1NSW-38 (sheet 2 of 2)  
Lower Containment Ventilation  
Unit 3 Supply Line

D-73B

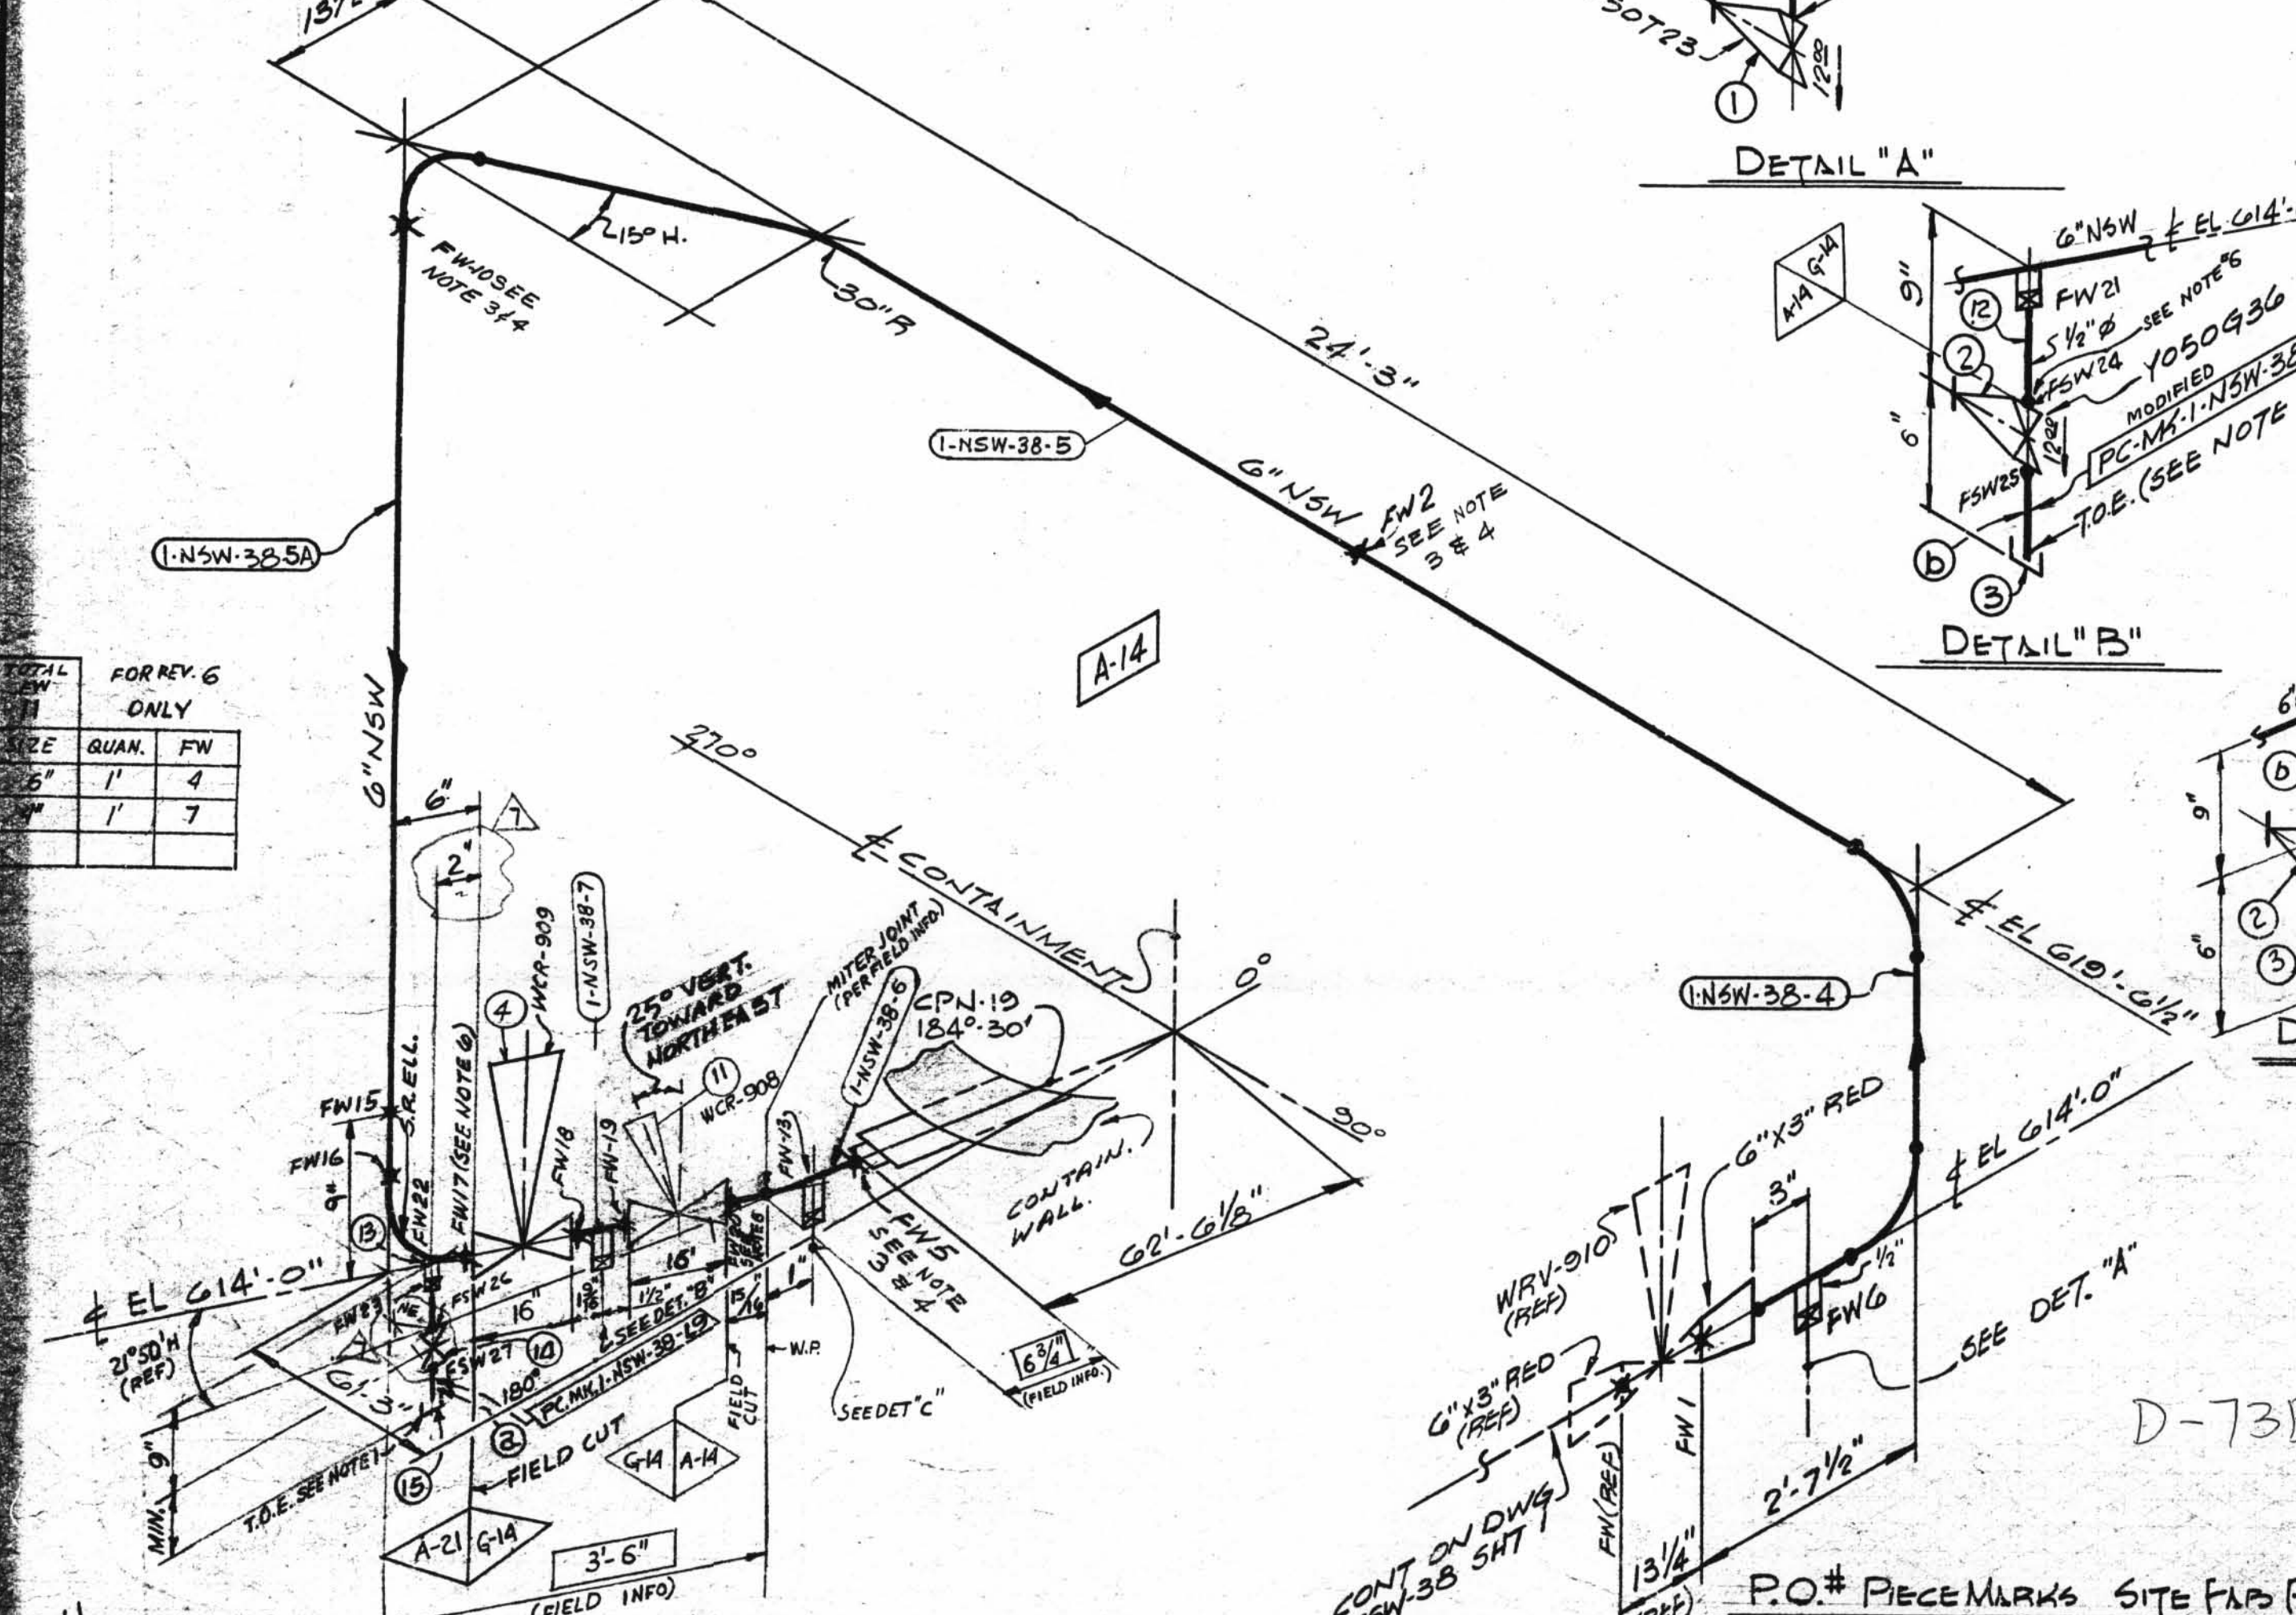
REV.	DATE	OR CHK	DESCRIPTION	REMARKS
1	12/19/71	SG, GN	RELEASED PIPING AT CPN. ADDED: NOTES 3, 4 (S); ITEM 4. WELD PROCEDURE; P.O. #; TOTAL NO. OF FW. PER DWG 1-5497-3	FIELD ACTION REQD
2	3/8/72	RZ, DB	DN. 6" WAS 5" AS FABRICATED. DELETED: WELD PROCEDURE NOTE, PER DWG 1-5497-4	N/A ACTION REQD
3	7/15/75	P, A	REV'D: ITEM 2, Y050636 WAS CY050636 REV'D BY A.E.P.	N/A ACTION REQD
4	2/20/76	DR	REVISED BY A.E.P. DESIGN PER A.E.P. DESIGN TO REFLECT AS BUILT WHEN CHECK VALVE WAS ADDED	N/A ACTION REQD
5	2/12/78	H.B.	PER RFC 12-1430 DELETED ITEM 5 & ADDED ITEM 6, 7, 8, 9, 10. SEE DETAIL 'C'	FIELD ACTION REQD
6	1/13/82	K.A.	PER RFC DC-12-2549 ADDED: PIPE SPEC. G-14, DN'S. PC-NK 7, LB 115. FIELD WELD. BOX. NOTES 6 & 7. ITEM 11'S 11/12 TO 5/11 DELETED. ITEM 11'S 5/11 FROM 8/11. REVISED ITEM 4 B/W. MODIFIED DC-NK 1-NSW-38-17	FIELD ACTION REQD
7	3/10/82	J.A. E.C.	PER RFC DC-12-2549 RELOCATED DR. VA. ITEM 11 & CHANGED DIRECTION OF HANDWELD	FIELD ACTION REQD
